**From:** Scala, Mary Joy  
**Sent:** Friday, September 25, 2015 9:08 AM  
**To:** 'Robert Nichols'; andrew@corecville.com  
**Subject:** BAR Action – September 15, 2015 –550 East Water Street

**Preliminary Discussion**  
550 East Water Street  
Tax Parcel 530162300  
Neal Sansovich, Owner/ Andrew Baldwin, Applicant  
New Mixed-Use Complex

**CITY OF CHARLOTTESVILLE  
BOARD OF ARCHITECTURAL REVIEW  
STAFF REPORT  
September 15, 2015**

# **550 WATER STREET MIXED-USE DEVELOPMENT**

**550 WATER ST MIXED-USE VIEW FROM NORTH**

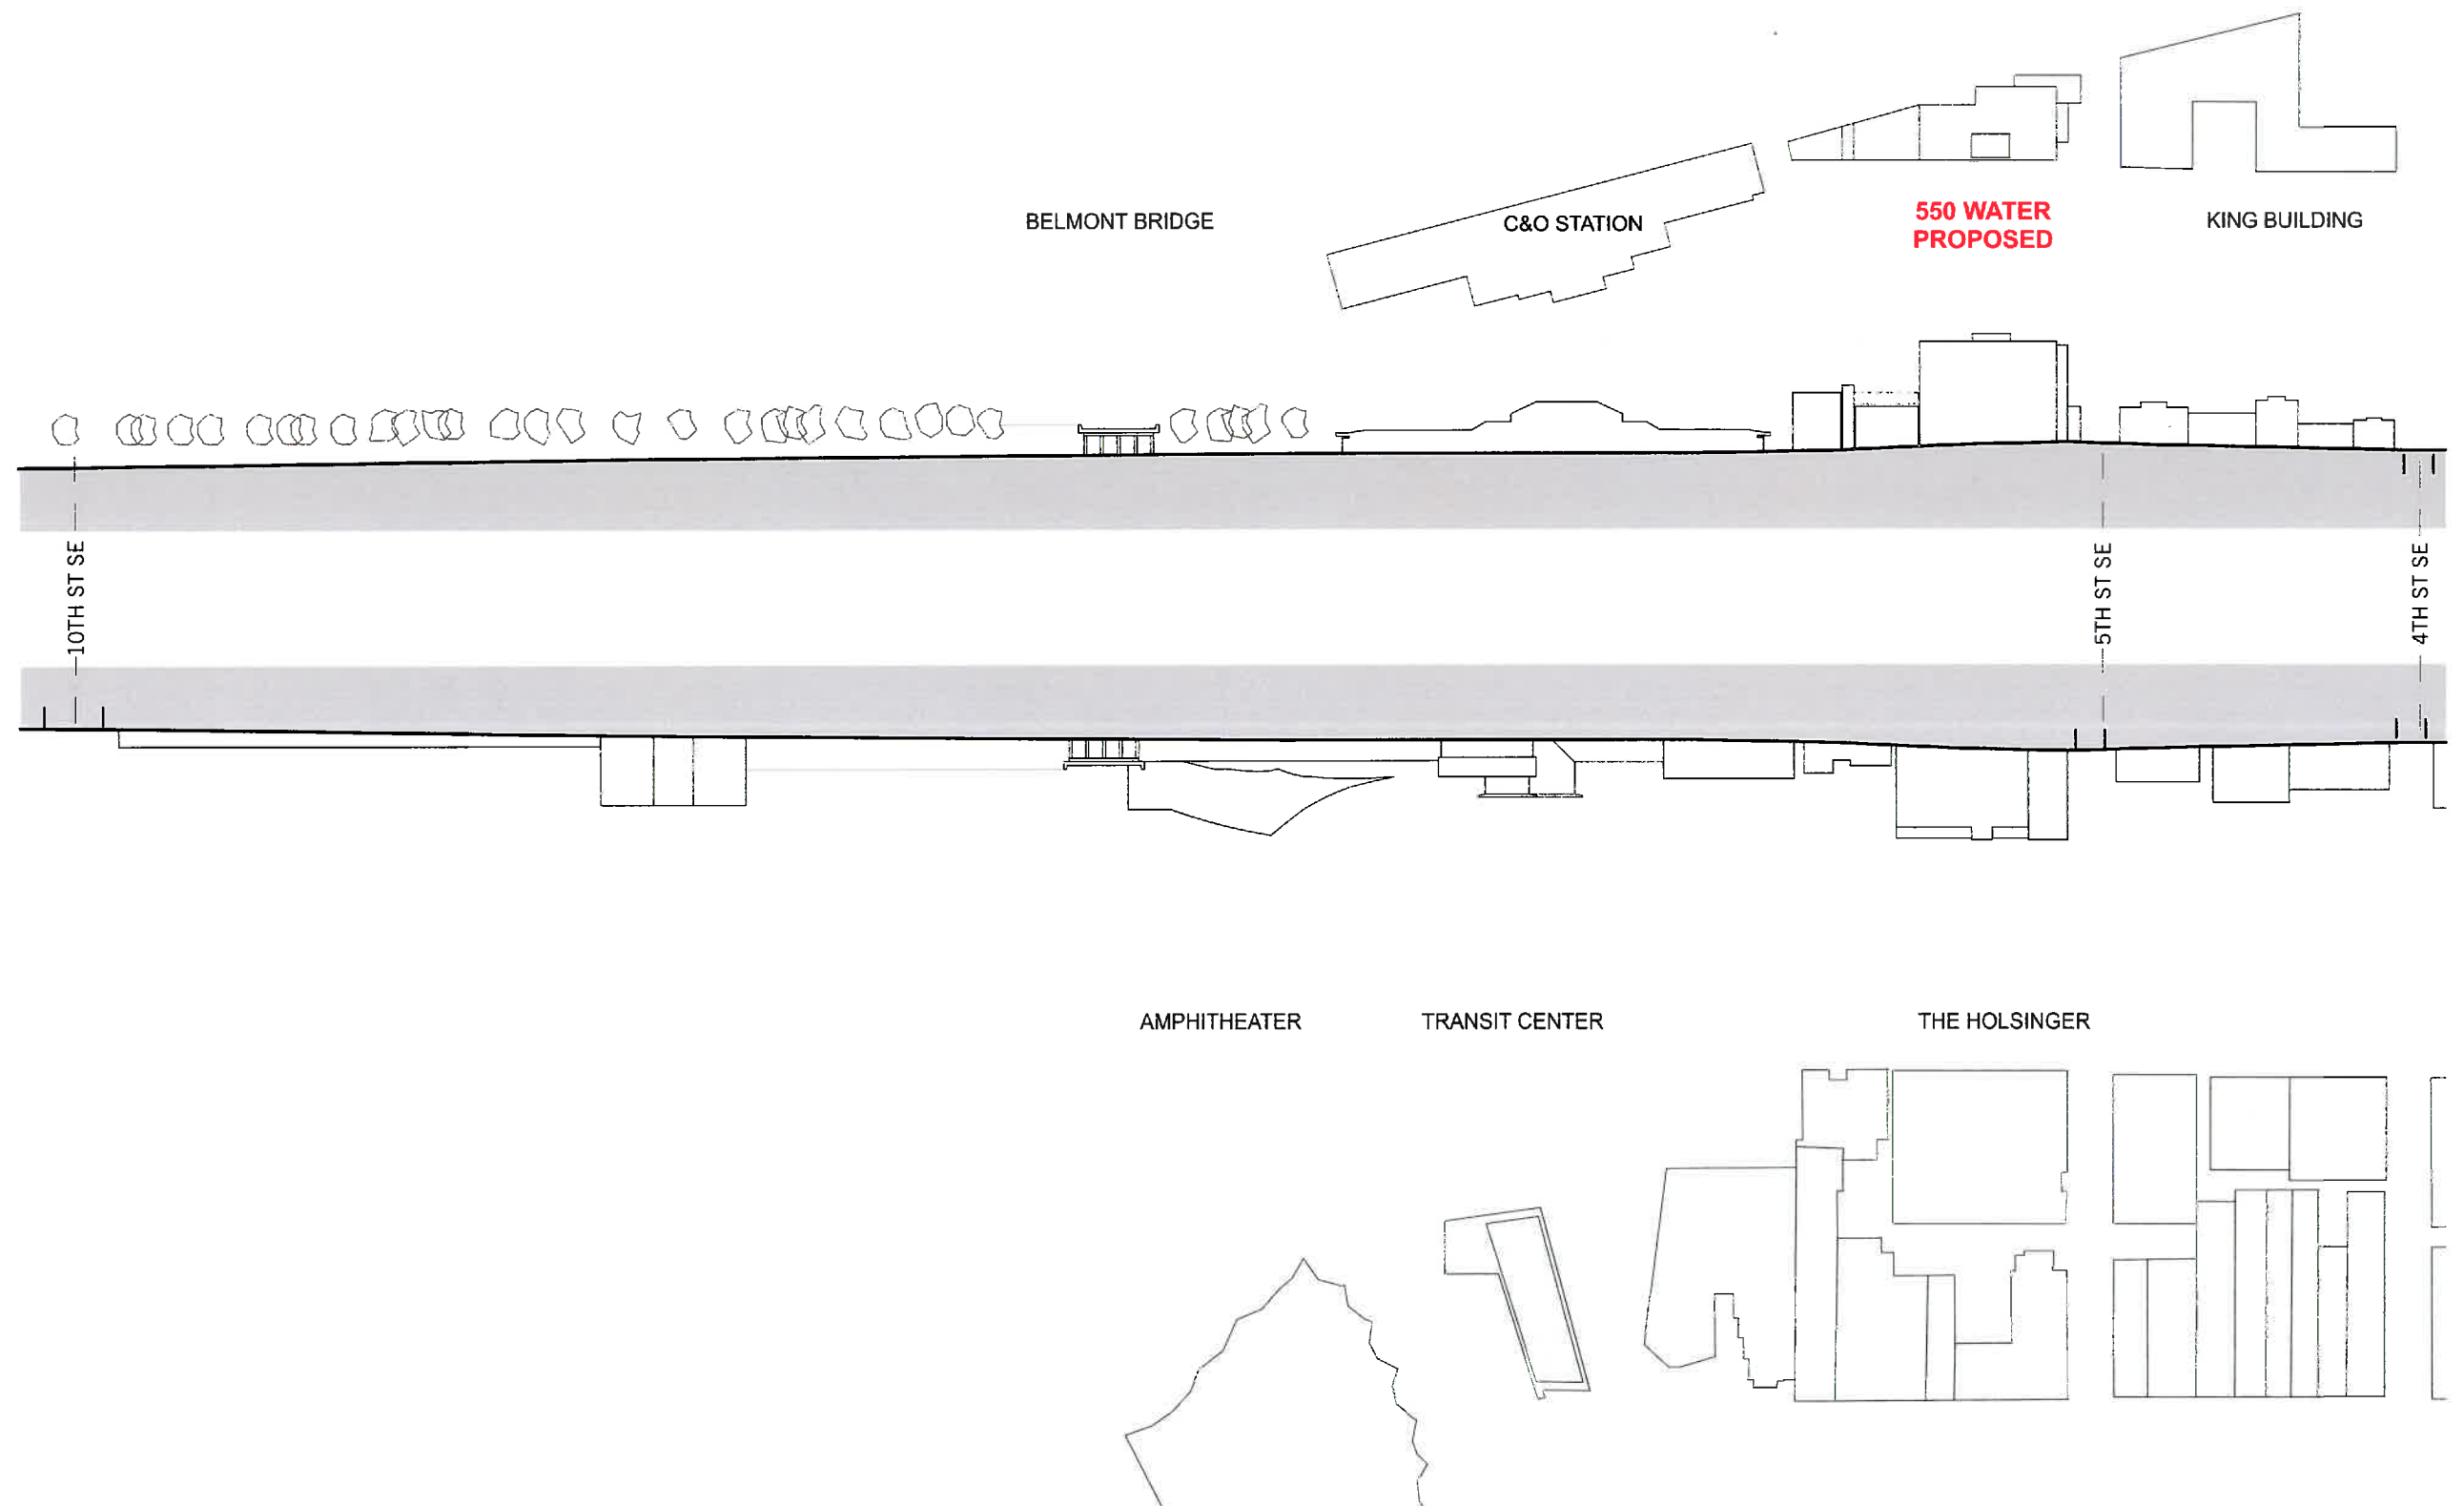
**Graves recused himself from the discussion. The BAR asked staff to provide an explanation of how height is averaged, with examples of how it has been done in the past.**

**Some comments: Lower height is huge improvement; continue to make it relate to smaller buildings on sides, similar to a 2-story building plus a top; richer texture/details on lower levels; garage opening and trellis are strong and help pedestrian experience.**
